S.A.F.E.'s Response To City Staff

Follow Up on our All Ages & All Abilities
Active Transportation Network Plan

December 7, 2023

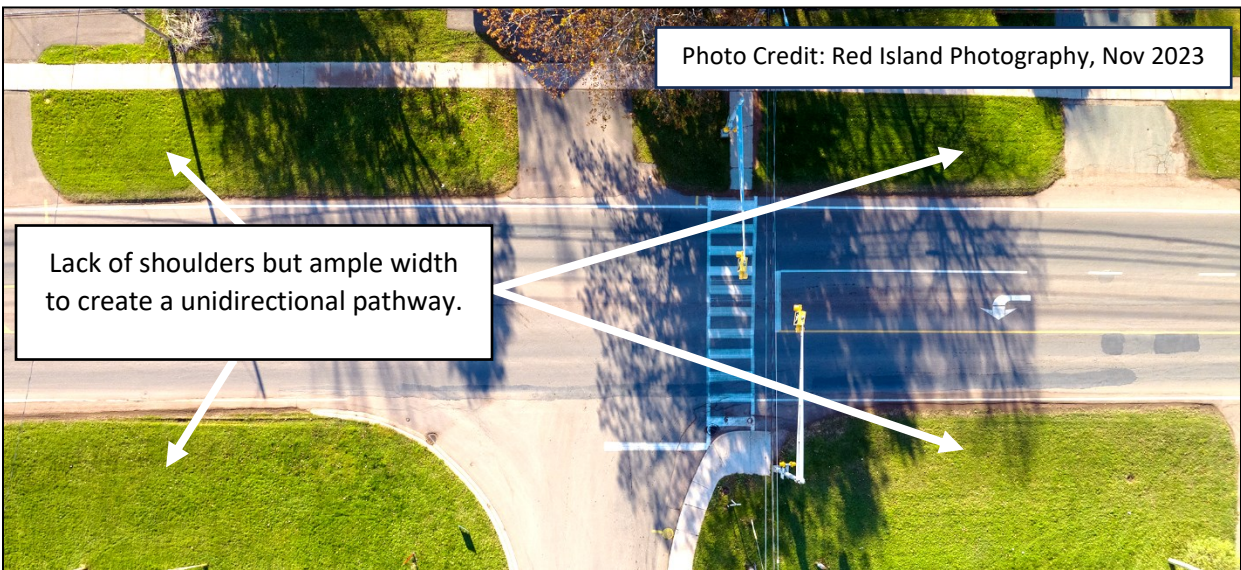
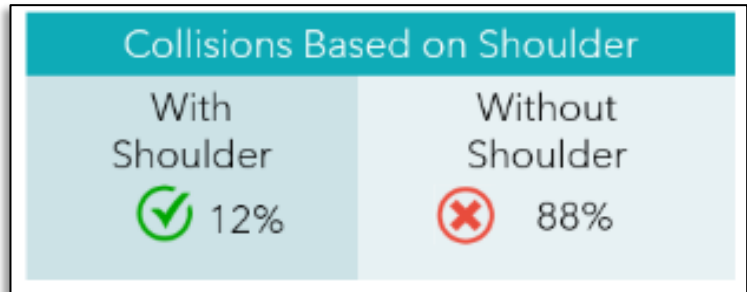
College of Piping to MacEwen Road: Consideration of narrowing roadway at College of Piping heading westward towards MacEwen Rd.

In our AT Plan, we addressed the need to increase the shoulder width for approx. 290 m (MacEwen Road to the College of Piping) on the south side and 380m on the north side (which includes utilizing Wyatt Crescent). Please refer to the Intersection Document for further details.

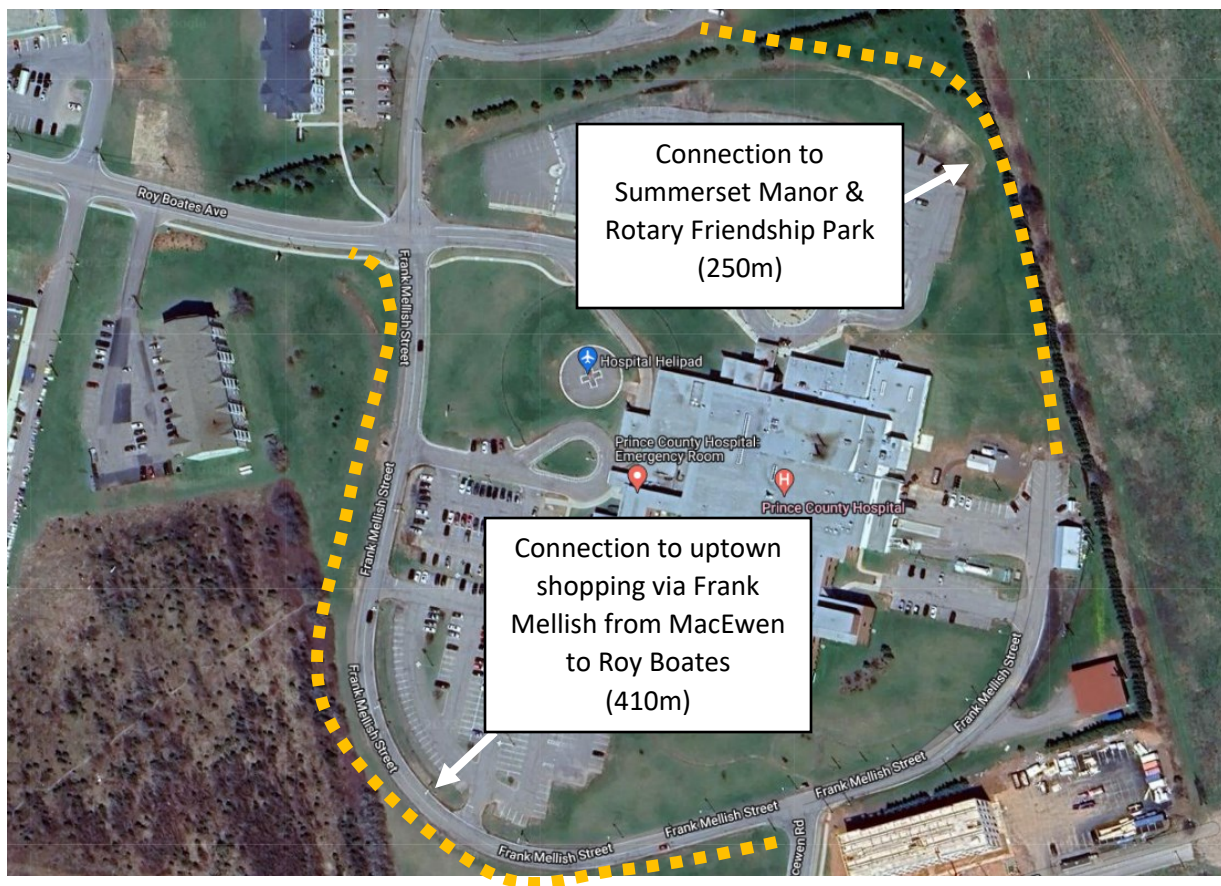
Connection to Upper Granville Shopping: Propose using Frank Melish St to connect to Roy Boates accessing Walmart/superstore area (suggestion originally included by Staff under Arcona Street but appears to fit better with MacEwen Road)

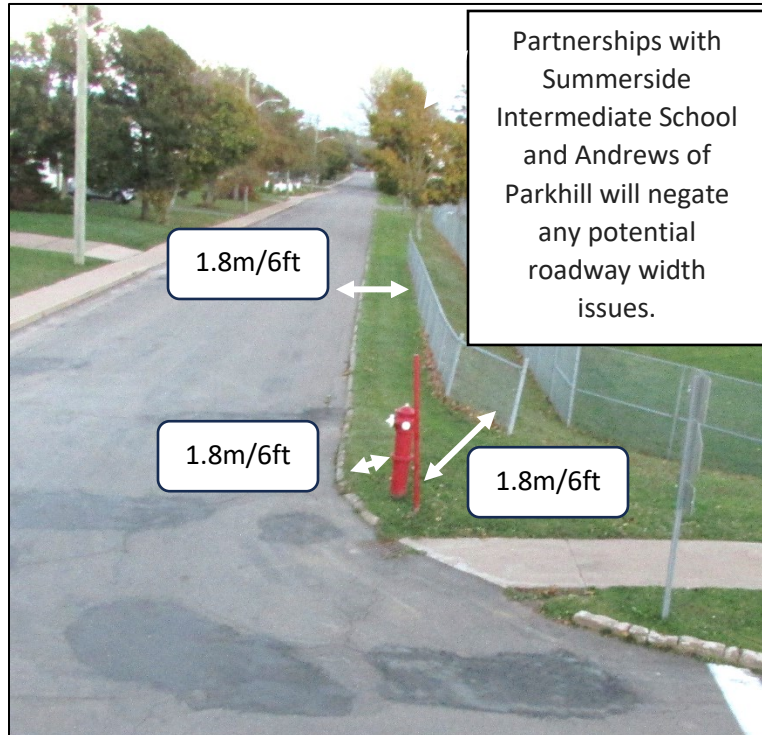
Roadway challenges with width

This short (200m) portion of Schurman Ave provides a unique opportunity for prevention and community partnership. First, prevention. Nestled between Parkside, SIS, Andrews of Parkhill, and a key route for AT traffic to Three Oaks, a protected AT pathway would provide safety for the most vulnerable road users.

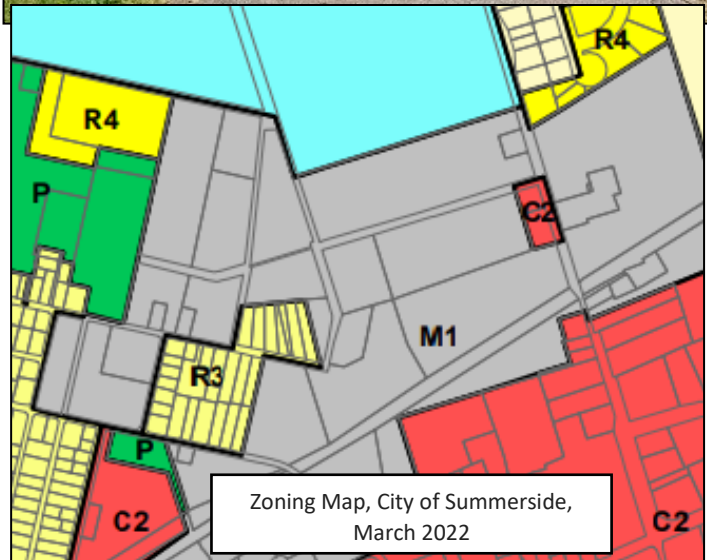
Very industrial, propose using rails to trails

We propose having both the Confederation Trail and Ottawa Street on the Network Map to provide options for AT users based on their level of level of on-street experience and confidence. By nature, on-street routes are for the more confident users. That being said, students at Three Oaks have often been observed bicycling after school and taking this route.

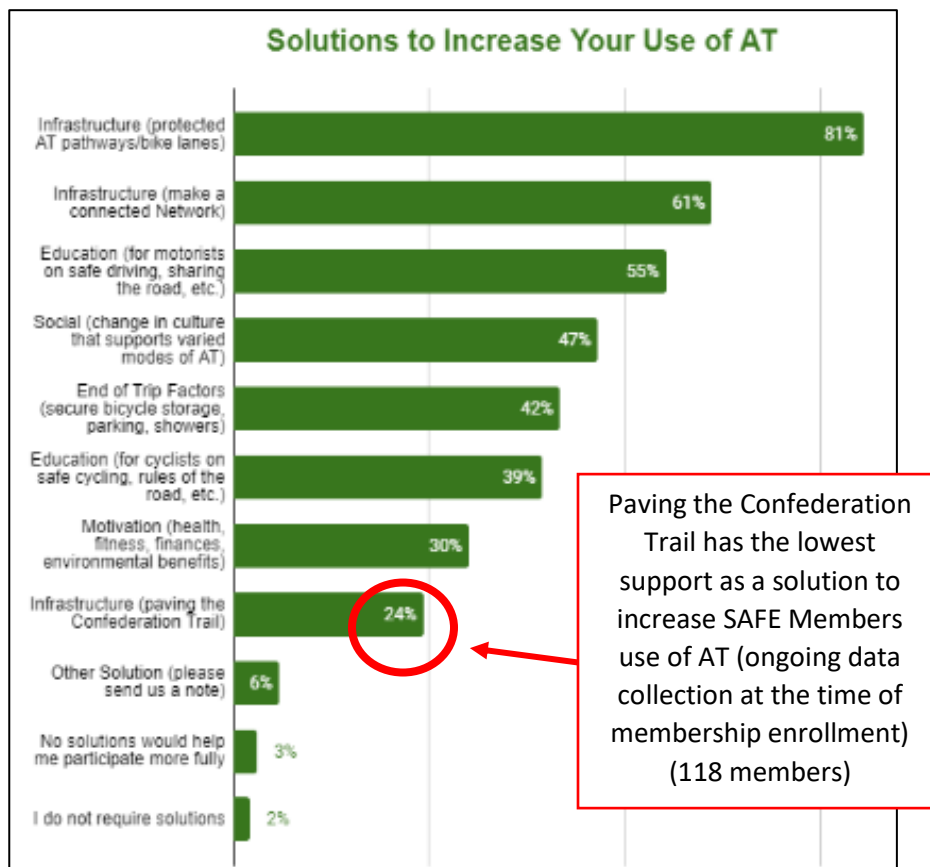
Highly useful existing connector, perhaps asphalt/lighting as part of plan

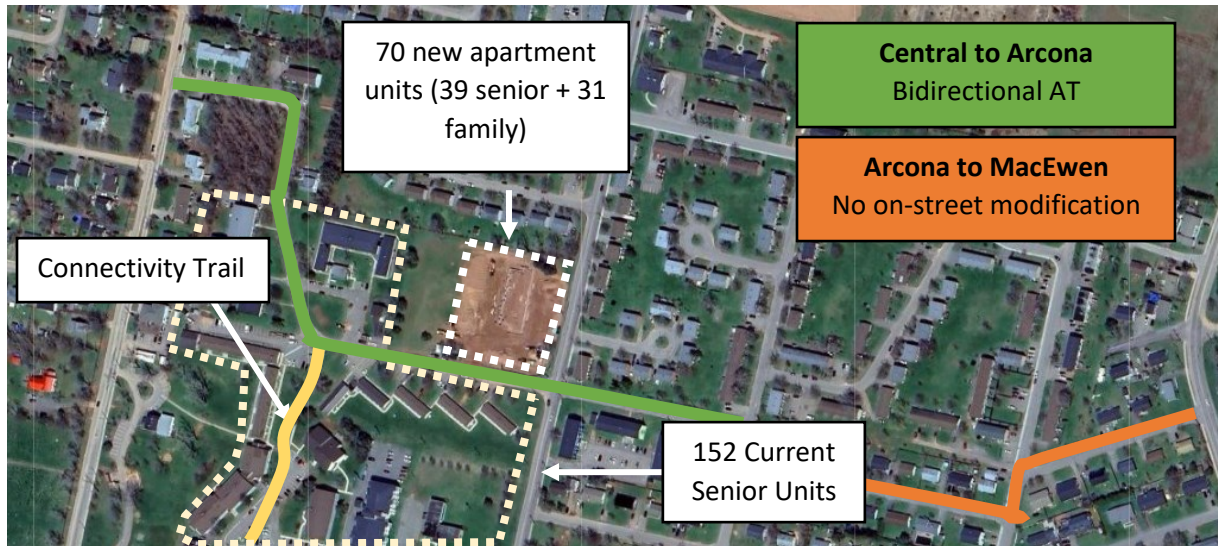
Private/provincial parking area considerations

This is an opportunity to provide needed active transportation and active living supports for a large group of elder population of the city. Please refer to page 4 in our Intersection Retrofit Recommendations as SAFE have consulted with the Parkview Senior Citizens Group.

2. Uptown Granville West Side

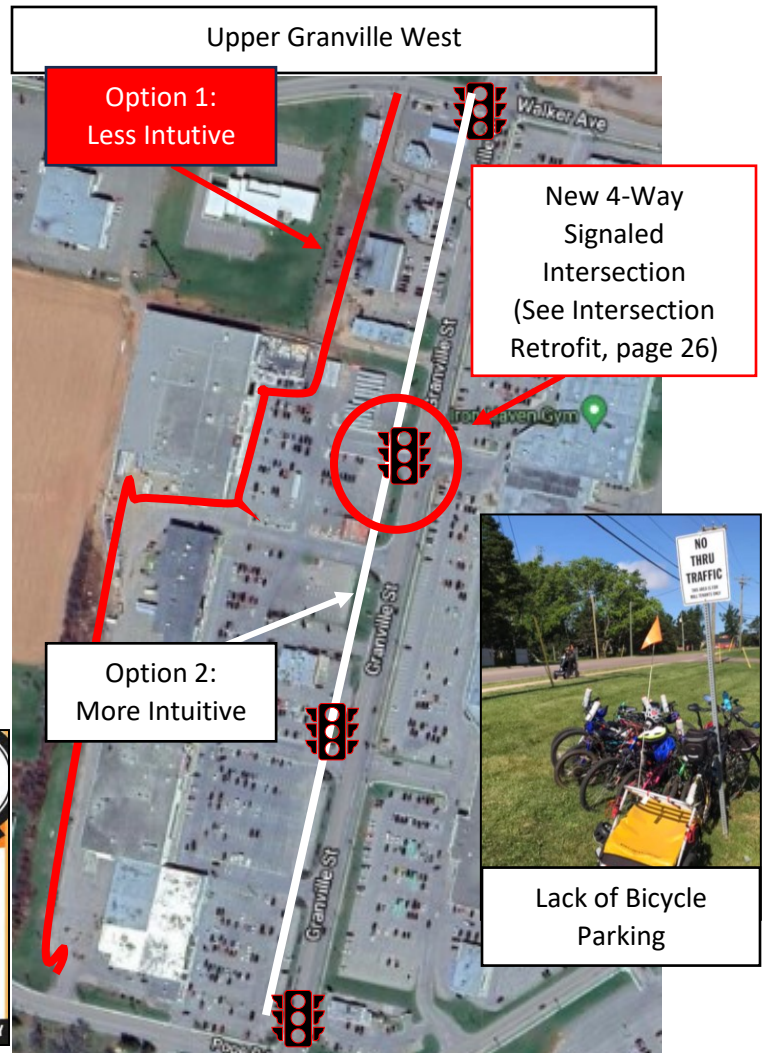
Essentially private shipping and receiving area for Mall?

There are **ONLY** two options to create safe upper Granville passage for the AT community. First, to keep AT traffic off Granville Street and navigate to Granville Street behind the Granville Street Plaza and through Canadian Tire parking, down the slippery slope (or, in the grass field behind Canadian Tire). While this option (that we recommended) is challenging, we attest the City is correct in highlight the issues with this route. It is not as straightforward as Gallant Street on the east side of Granville.

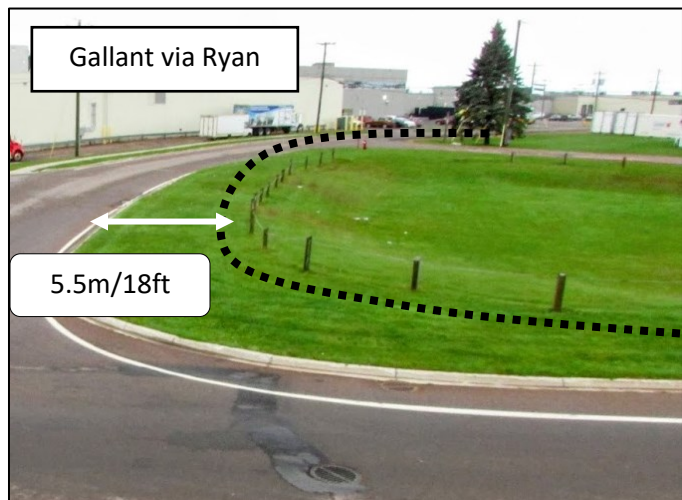
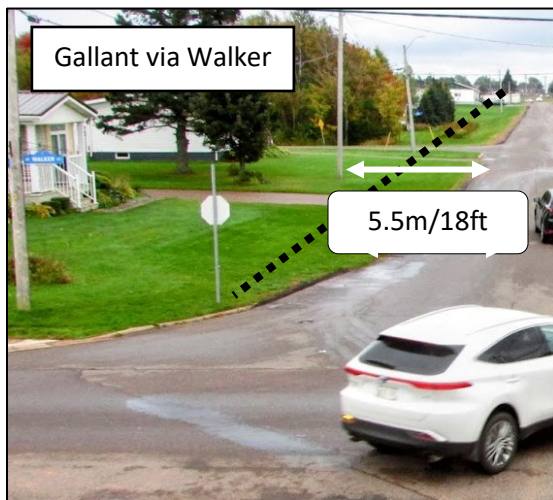
City Staff are proposing to avoid Gallant Street and the Gallant Street Extension based on crossing private property and to follow the Frank Mellish/Roy Boates route.

We propose a combination of both routes for AT users on Gallant Street, the Gallant Street Extension would be more intuitive, and vice versa.
